GM Bulletin No.: 30670

# SERVICE UPDATE

**SUBJECT:** Service Update for Inventory and Customer Vehicles

**Parking Brake Cable Rubbing Noise**

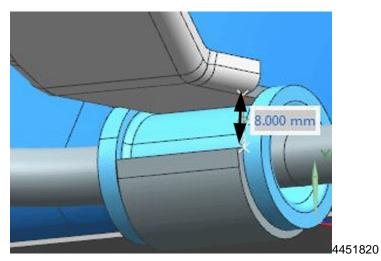
3. Open the gap of parking brake cable mounting clamp from 4mm to 8mm using pliers and trim remover or equivalent as shown.
